In the drawings:

Please approve the proposed drawing changes shown in red on the attached copies of drawing sheets containing Figures 1, 2, 4, 5 and 9/8C. Reference numbers are revised in Figures 1, 2, 4 and 5. The drawing figure labeled "Figure 9" has been corrected to identify the Figure as "Figure 8C", as identified in the original application papers. No Figure designated as "Figure 9" was originally filed. Replacement sheets of formal drawings containing the changes are concurrently filed herewith.

Annotated Marked-Up Drawings

1/10
DORIS ET AL.
JPA FIS920030264US1

FIGURE 1

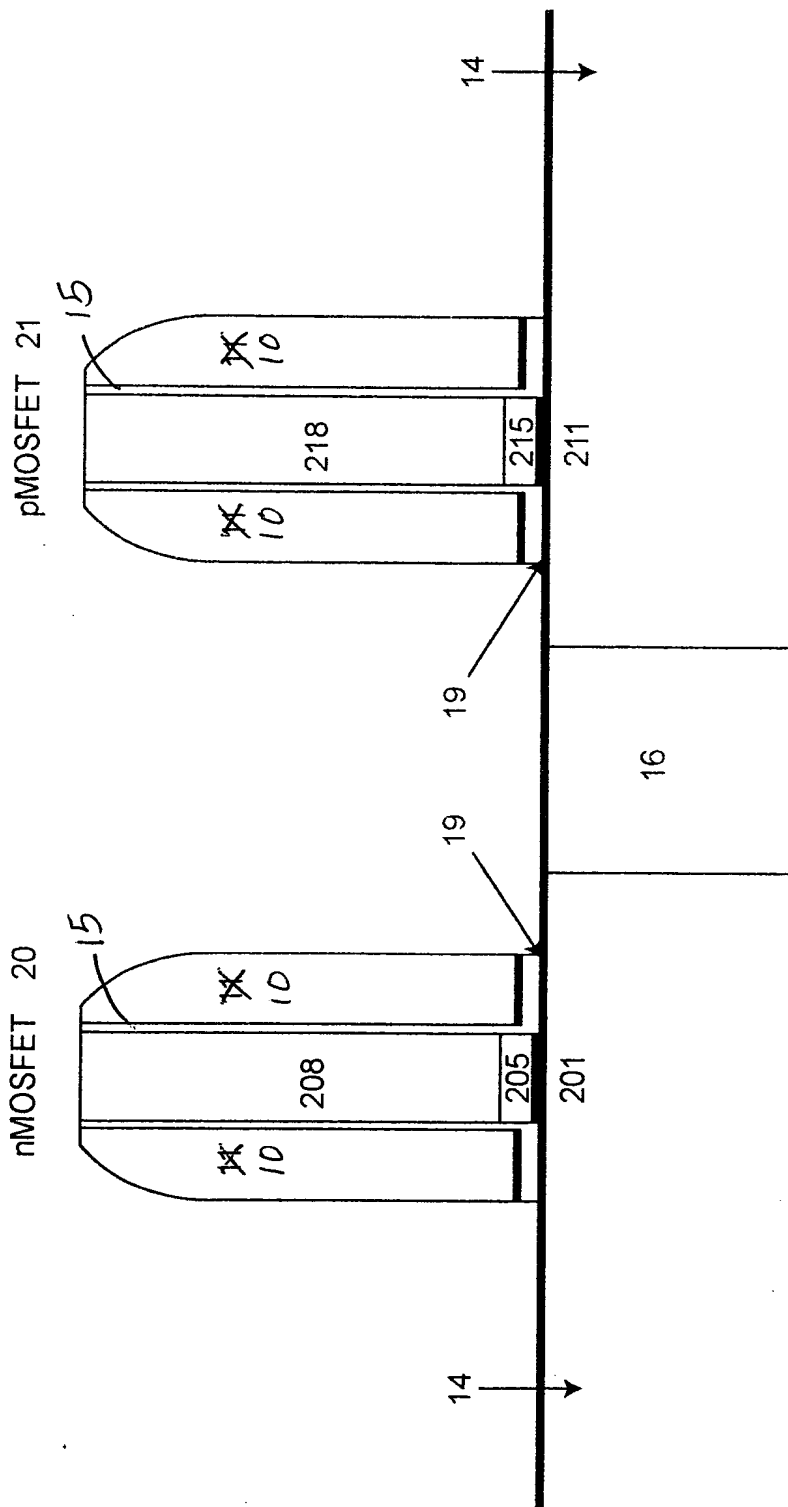
The Examiner has objected to the drawings as failing to illustrate the recited source drain and gate silicide. This objection is respectfully traversed since these claimed features are, in fact, illustrated. Reference numbers have been revised in the specification and, in some cases, applied in the drawings to clarify the illustration thereof. Additionally, since it appears that the term "silicide" (being a common feature of many known transistor designs) is unnecessary to a recitation of the distinguishing features of the invention, the term
